RE: Initial Submission Review – Kings Point South PAS 1-4 – Site Plan
and Plat Application Number: DA-1628-06
Case Numbers: 2022-4037-00, 2022-3063-00

This letter is in response to the City of Aurora's comments dated August 26, 2022. Comment responses are shown in *red*.

PROJECT: KINGS POINT SOUTH
 DRAWING: SITE PLAN
 CLIENT: CITY OF AURORA
 DESIGNED BY: AJZ
 DRAWN BY: STM
 CHECKED BY: AJZ
 DATE: 9-21-2021

SHEET NUMBER
L-2
SHEET 21 OF 34
PROJECT NO. 8677-000

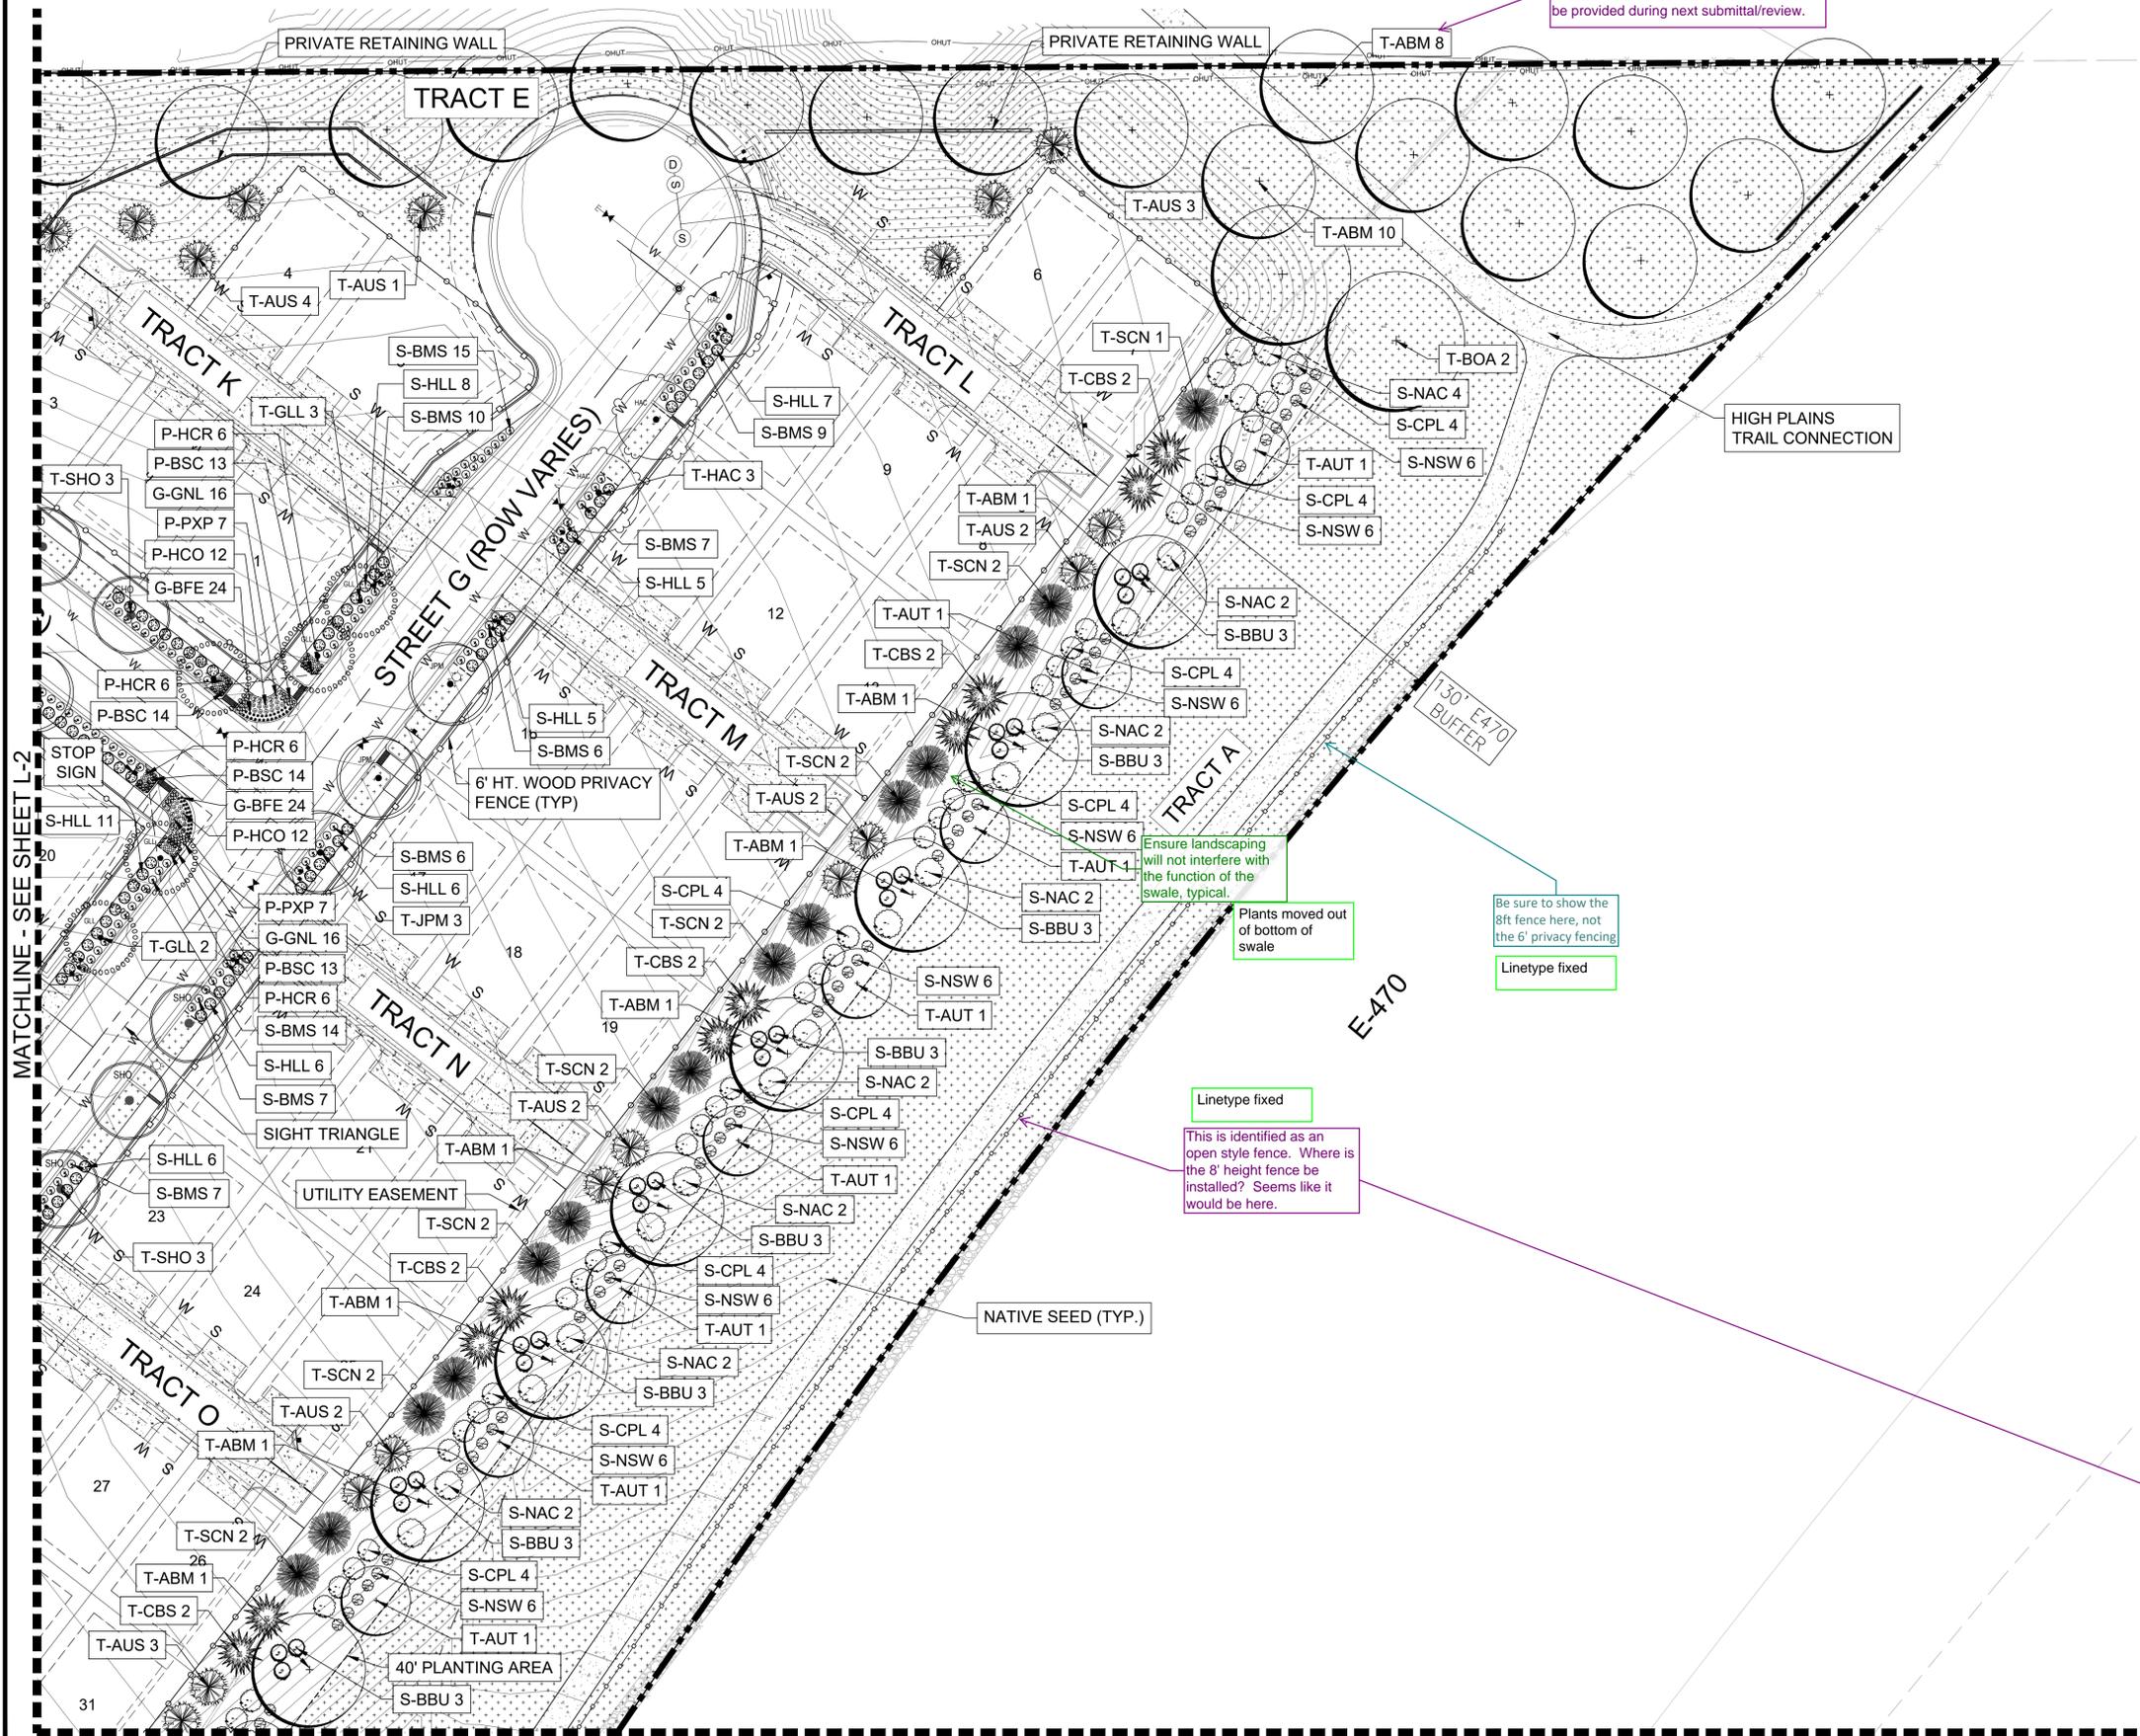
13M. To comply with PROS' policy for inclusive access, what playground feature is intended to provide meaningful opportunities for children of different abilities to interact, play and learn together? A specialized piece of play equipment should be provided which goes beyond basic ADA accessibility. *Inclusive play equipment added*

13N. Is this the primary inclusive play feature for this playground? *Inclusive play equipment added*

13P. Benches should be setback from the trail, perhaps placed on their own concrete pad. *Bench pads added*

13Q. Pet waste stations are needed in the park and along the connector trails. Provide where appropriate and add detail to the Landscape Detail sheet. *Pet waste stations added*

13R. Label the slope of paths/trails in the park. Typical. *Slope labels added*

13S. This bold pattern/symbology makes it difficult to read much of the plan. *Symbol changed*

13T. A concrete pattern defined by legend does not appear for paths/trails. *Added to plan*

13U. Difficult to discern on the plan where trash receptacles are provided. Typical. [Site Plan Page 22] *Labels added*

SHEET NUMBER
L-3
 SHEET 22 OF 34
 PROJECT NO. 8677-000

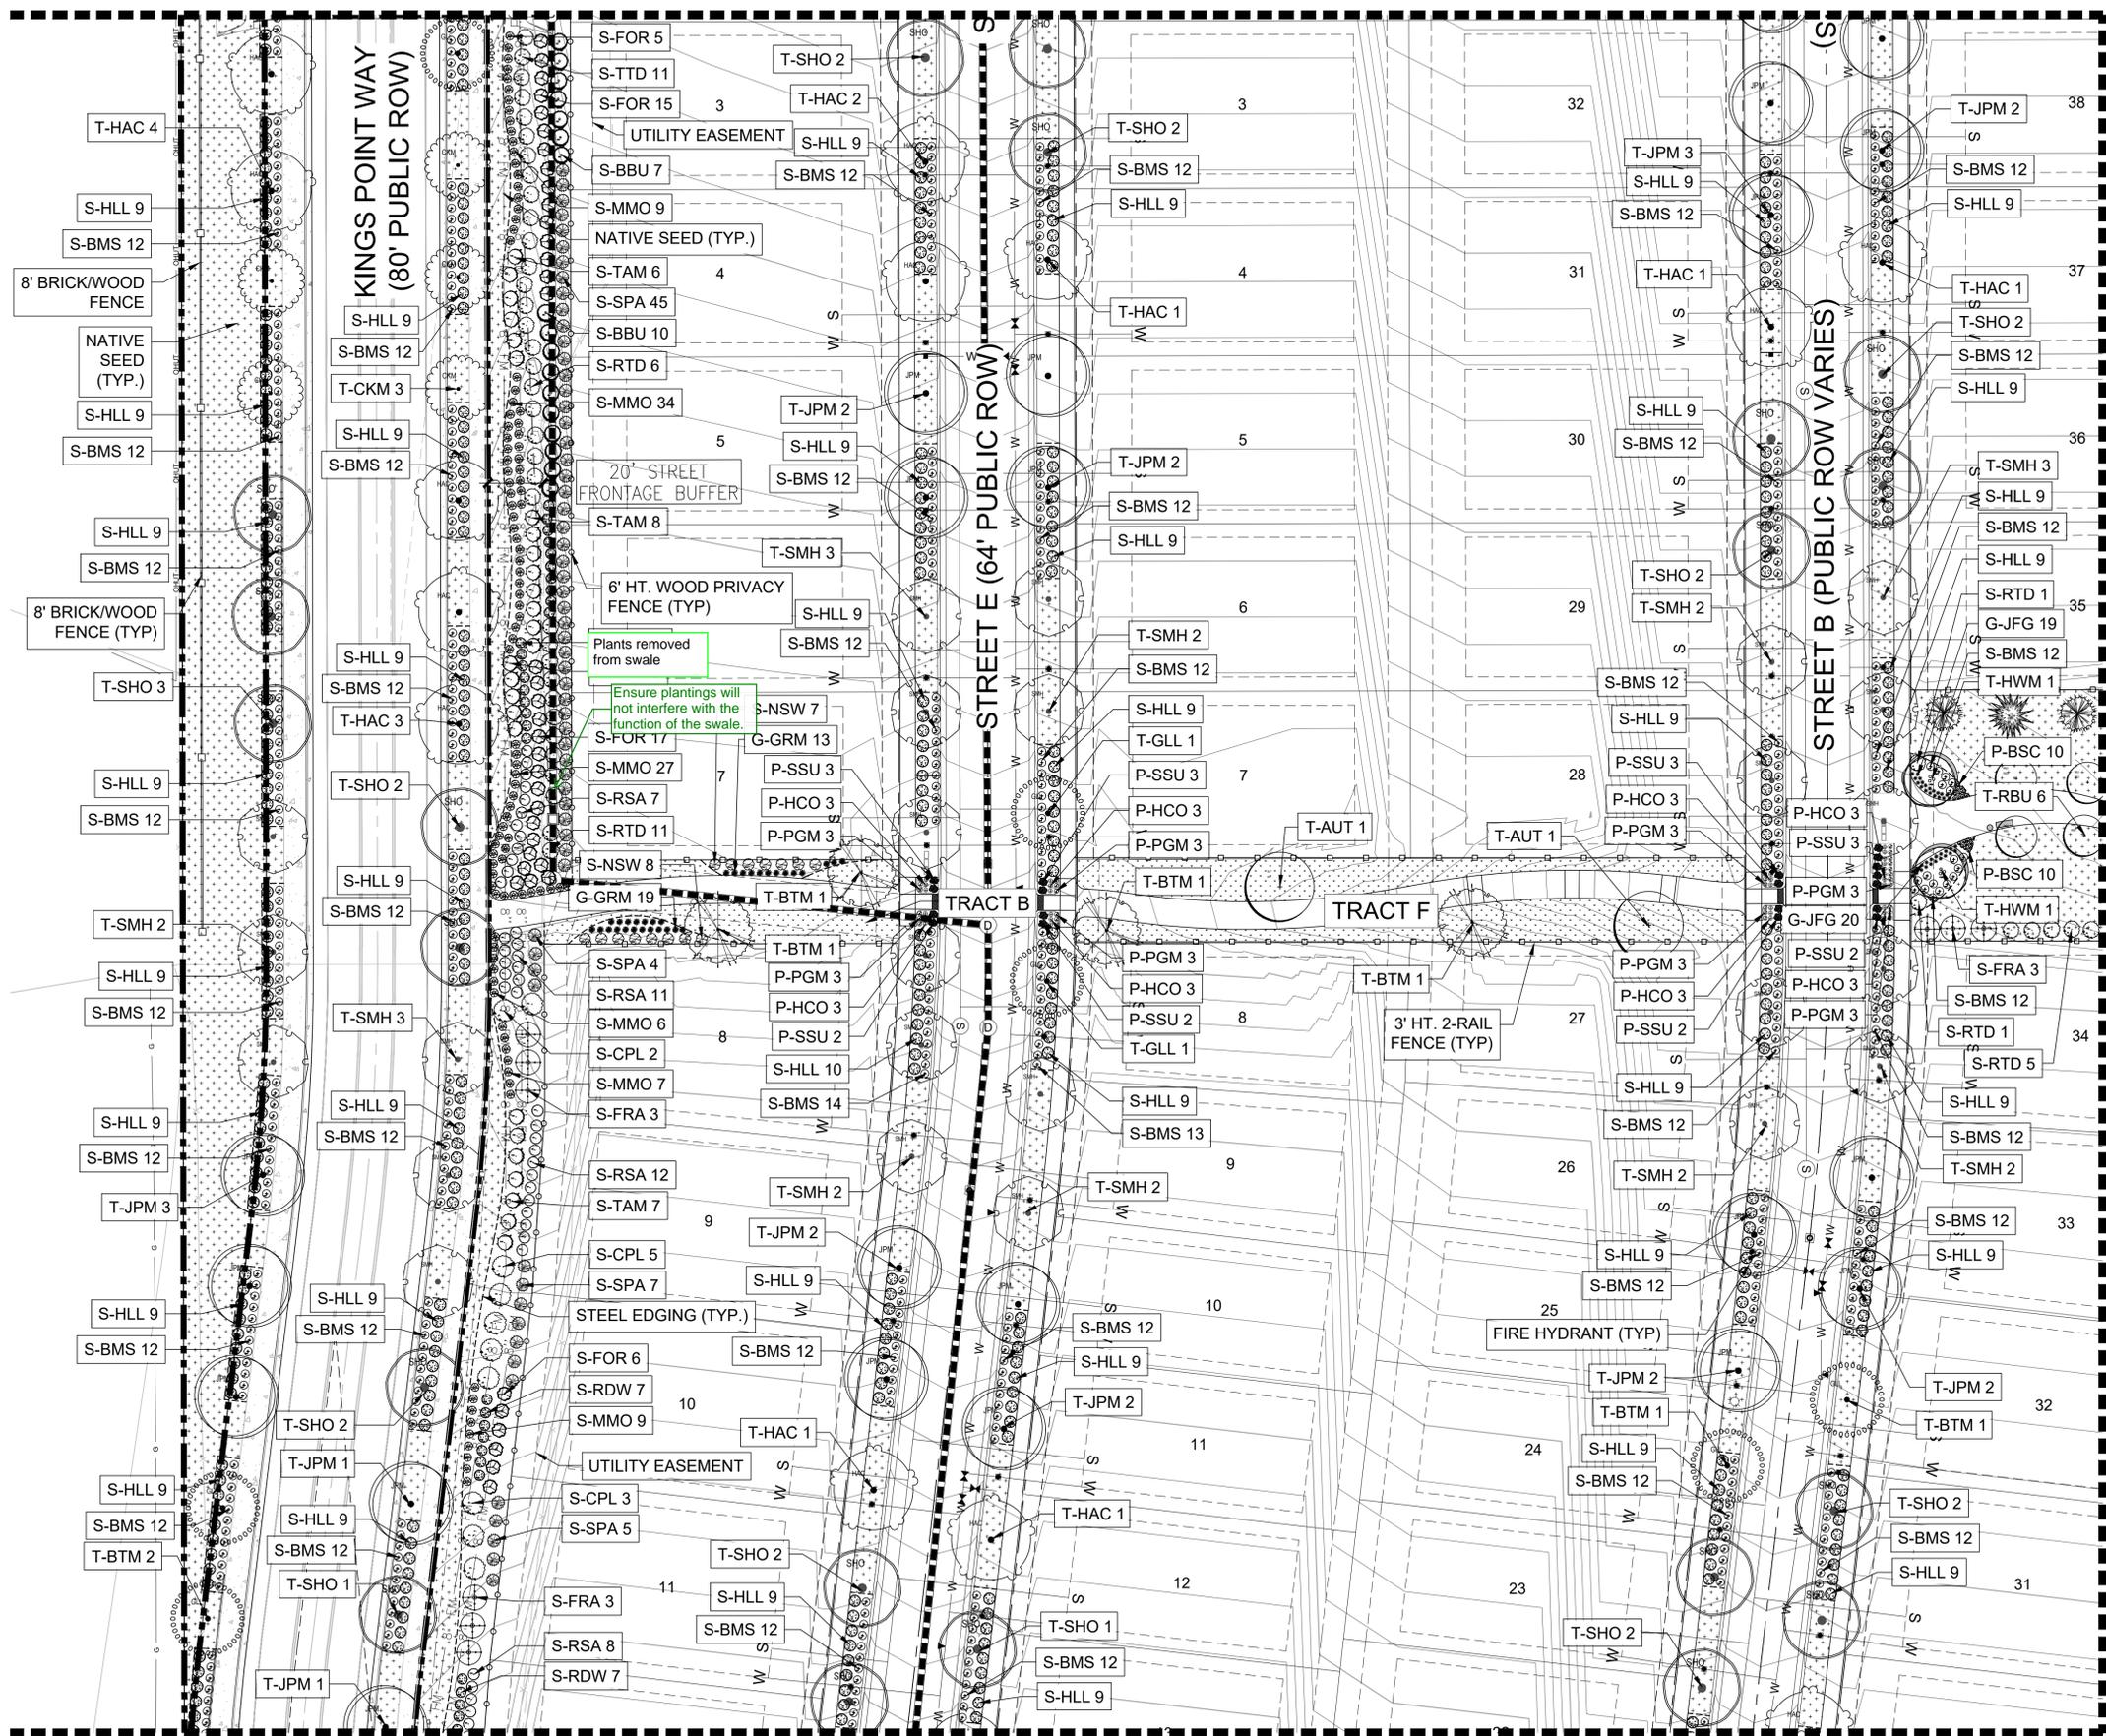
9Y. Ensure landscaping will not interfere with the function of the swale, typical. [Site Plan Page 23] *Plants moved out of bottom of swale*
